E4431B-11**S E R V I C E N O T E**Supersedes:
NONE**ESG “B” Signal Generator E4431B**

Defective Waveform Sequence SRAM on the Dual Arbitrary, UND board (A5) and iDEN Dual Arbitrary, Special Option H60 board causes waveform become distorted when playback.**To Be Performed By: Agilent-Qualified Personnel****Parts Required:**

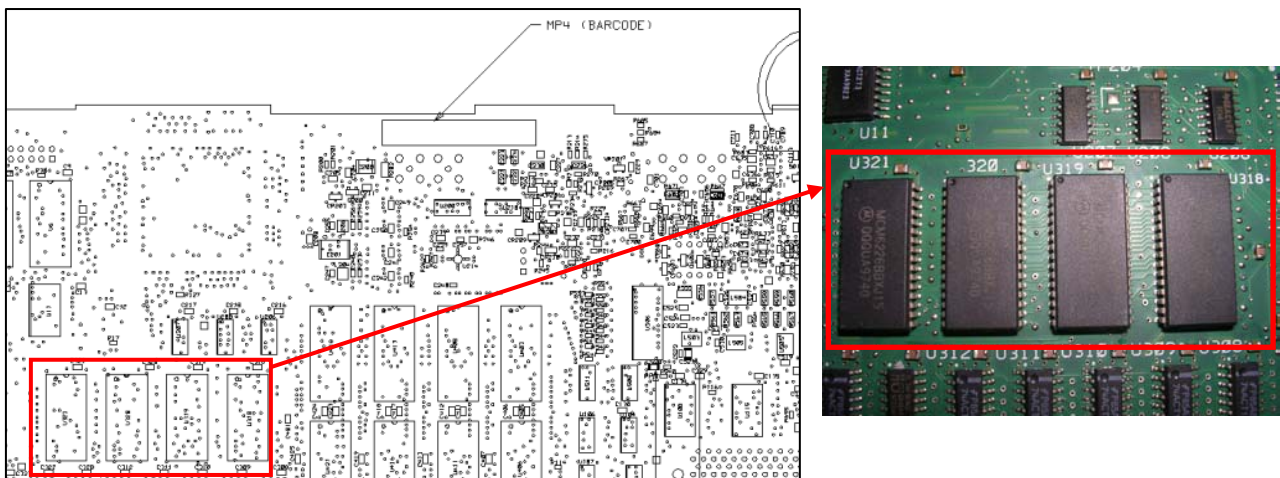
The ESG-B D/DP Family of Signal Generators has been experiencing failures in the UND (E4400-60187) and Option H60 (E4400-60186) board assemblies. This is due to a failure of the waveform sequence SRAM ICs. There are total 4 affected waveform sequence SRAM ICs on the UND and Option H60 assembly, designator U318, U319, U320, U321. The failure will cause the waveform playback become distorted. This may happen immediately after Arbitrary Function is turned on, or after it has been play-backed for a short period of time. This potentially happened when large waveform files are being playback. All ESG-B D/DP units with the symptoms mentioned above required the waveform sequence memory chips to be replaced. The kit, E4400-60753 contains 4 pieces of the SRAM ICs.

1. Repair on failure.
2. Prevent future occurrences due to a defective waveform sequence memory chips (U318, U319, U320, U321) by replacing the 4 affected chips.
3. Locate the U318, U319, U320 and U321 which are located at the bottom side of the UND or H60 board.

4. Replaced the affected components. **Caution:** Please use the appropriate soldering tools and you must be certified to perform the soldering to prevent any quality or reliability issue due to soldering workmanship.
5. Once the affected components had been replaced, perform:-
 - i) Dual Arb Waveform Generator Check. This test can be performed by using the TME software or the ESG-B Classics Software, and
 - ii) If customer waveform is stored in the NVARB RAM, playback the waveform and observed on the oscilloscope for any waveform distortion.
